Stage 1 Lattice: Baseline Change Request

LhARA Fortnightly Meeting

07th November 2023

7 Gabor Lens Configuration

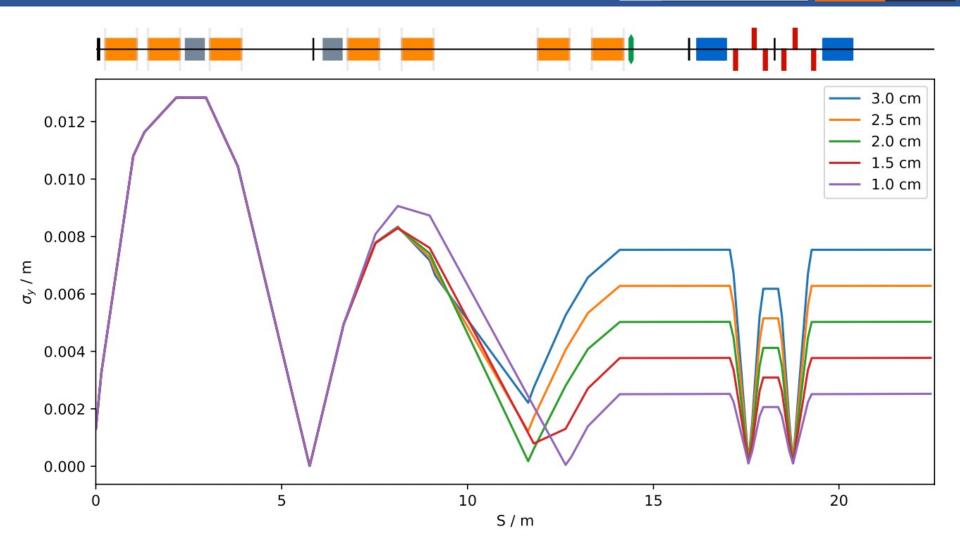
- Proposed new configuration using 7 Gabor lens / solenoids
- Matched solutions for 5 spot sizes & FFA injection (no space charge):
 - 3.0, 2.5, 2.0, 1.5, 1.0 cm (2 σ diameter)
- Single energy collimator
 - Second in 5 lens baseline design for stage 2 operation

Capture Section Optimisation

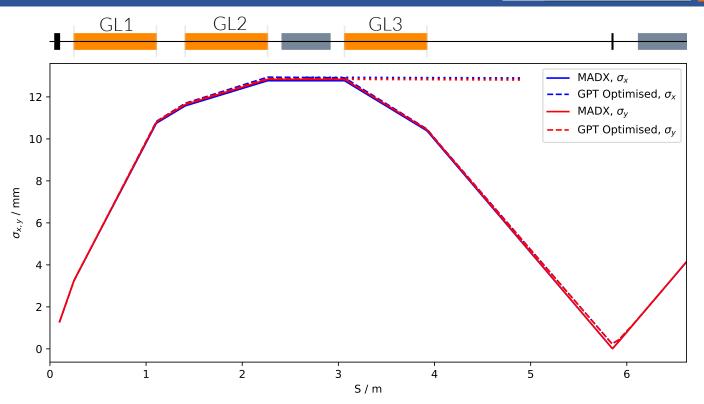
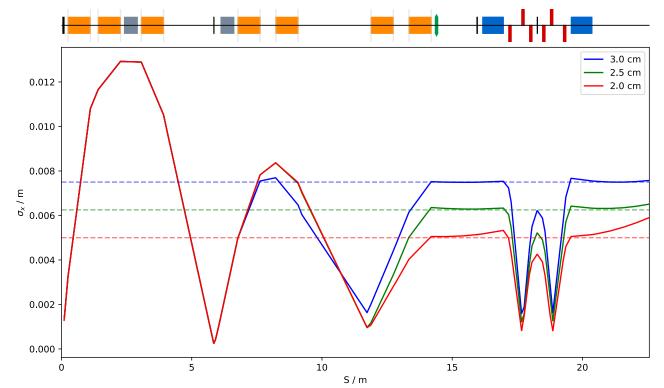
Machine length
 flexibility between
 GL2 & GL3 achieved
 ~ 2.5 m

Original		Optimized	
	KS	B [T]	KS	B [T]
Gabor Lens 1	2.491764	1.4	2.491764	1.4
Gabor Lens 2	1.018776	0.572400	1.045545	0.587440
Gabor Lens 3	1.448605	0.813900	1.449852	0.814601

Spot-size Optimisation

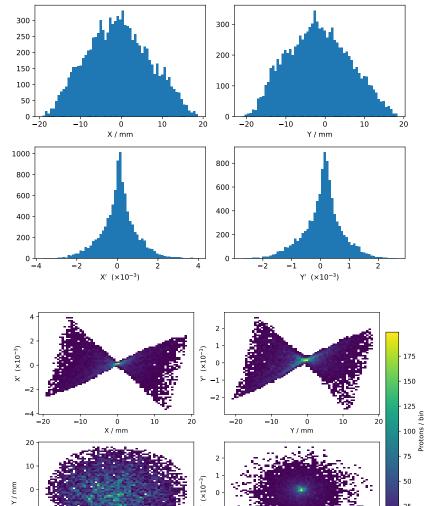
- Optimised solutions found for 3.0, 2.5, and 2.0 cm spot sizes
- Trending to divergent beam, focus after GL7.

Spot Size [cm]	Solenoid Equivalent Field [T]			
	Gabor Lens 4	Gabor Lens 5	Gabor Lens 6	Gabor Lens 7
3.0	1.072940	0.807211	0.001191	0.787153
2.5	0.996313	0.832585	0.000871	0.858701
2.0	0.995976	0.823955	0.749300	0.836557

2.0cm Spot Size: Arc Optimisation

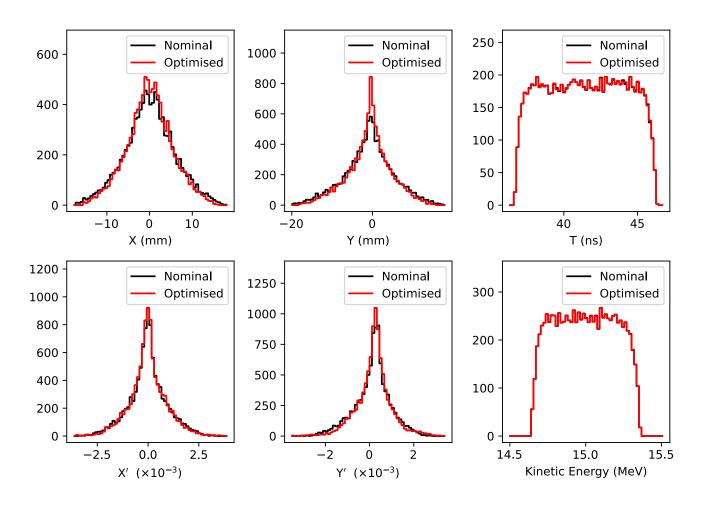
- Arc quadrupoles varied, improved solution for 2.0 cm spot size beam.
 - Quad gradient constrained to ± 22.4 T/m (pole tip field = 0.82 T, 3.65cm radius)
- Arc quadrupole strength variability likely required.
- Solutions for smaller spot sizes remains challenging.
